Subject: Reply to NRC Inspection Report No. 99901468/2016-201 Notice of Nonconformance

References: NRC Notice of Nonconformance Docket Number 9901468/2016-201-01

NRC Finding Response

Section I - Technical justification - Commercial Grade Dedication of Spindle

Figure 3 – von Mises stress plot

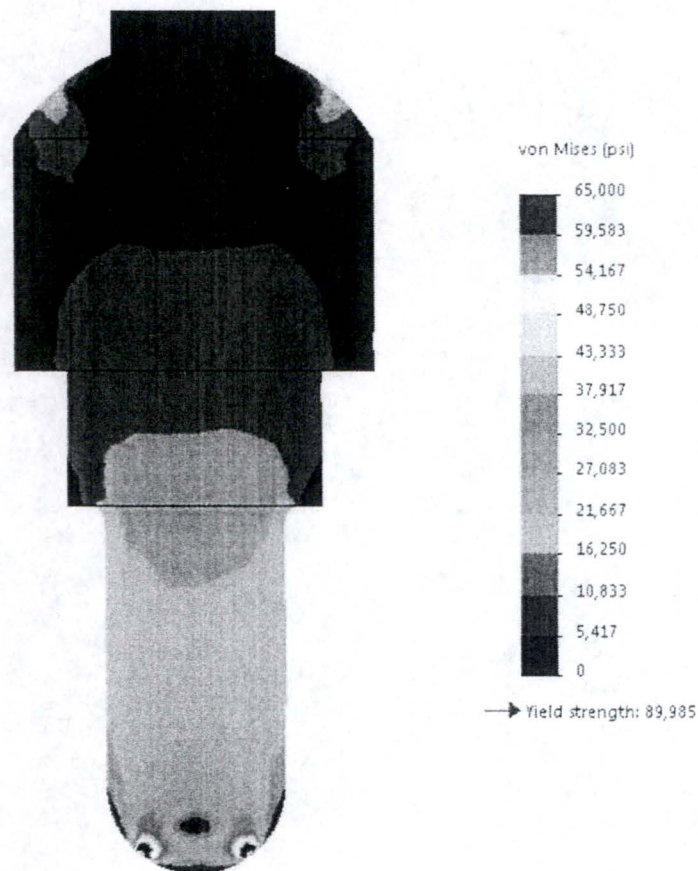
Compressive stress is the primary membrane stress acting on this part. At the maximum pressure/temperature combination (6000 psi at 100 °F), the maximum membrane stress (Compressive Force corresponding to 6000 psi/ Nose cross sectional area) for this part is 17300 psi with a Factor of safety for yield at 6.65. A Finite Element Analysis was also performed to verify the hand calculations. Figure 3 shows the equivalent stress across the cross section of the "nose" of the spindle.

Coining or Brinelling failure (permanent deformation at the surface) is caused by peak stresses acting on the surface of the part. The maximum contact stresses are present at the point of load transfer from the spindle to the disc. The part failure is noticed as cracks, pits or flaking of the surface material. The Hertzian contact stress (peak stress) for the spindle at the bearing point is 58,800 psi (3.4 x Membrane Stress). Figure 3 also provides FEA verification of the calculated contact stress values.

The weak link failure mode for the spindle is failure due to coining or brinelling at the bearing point of the spindle where the load gets transferred. Since the weak link failure mode is due to contact stresses, the hardness of the spindle was the primary mechanical property characteristic chosen for commercial grade dedication of the spindle as it provides the best assurance against the brinelling failure mode.
